| Product/Process Change Notice (PCN) | | |
| PCN Number: PCN_FrqXTAL_20250218 Affected Series: WE-XTAL Affected Part Number: 830025159 PCN Date: 2024-11-18 (YYYY-MM-DD) Effective Date: 2025-02-18 (YYYY-MM-DD) | Change Category: <input type="checkbox"/> Equipment/Location <input checked="" type="checkbox"/> General Data <input type="checkbox"/> Material <input type="checkbox"/> Process <input type="checkbox"/> Product Design <input type="checkbox"/> Shipping/Packaging <input type="checkbox"/> Supplier <input type="checkbox"/> Software | |

2. Correction of the Product Dimensions:

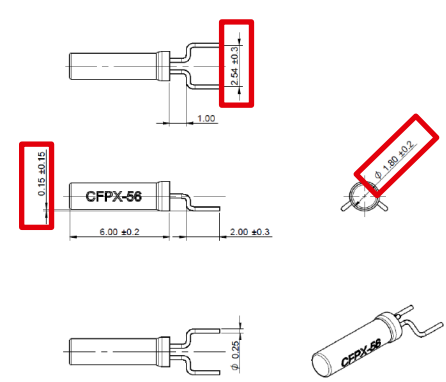
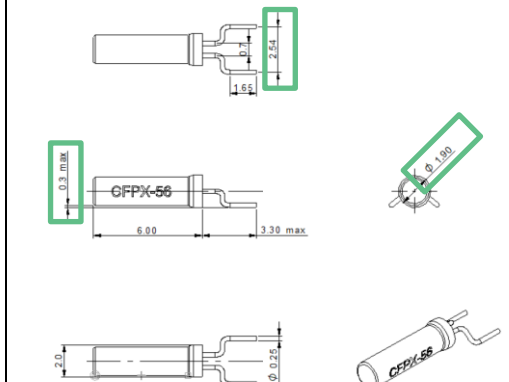
| | Before | After |
|--------------------|---|--|
| Product Dimensions |  |  |
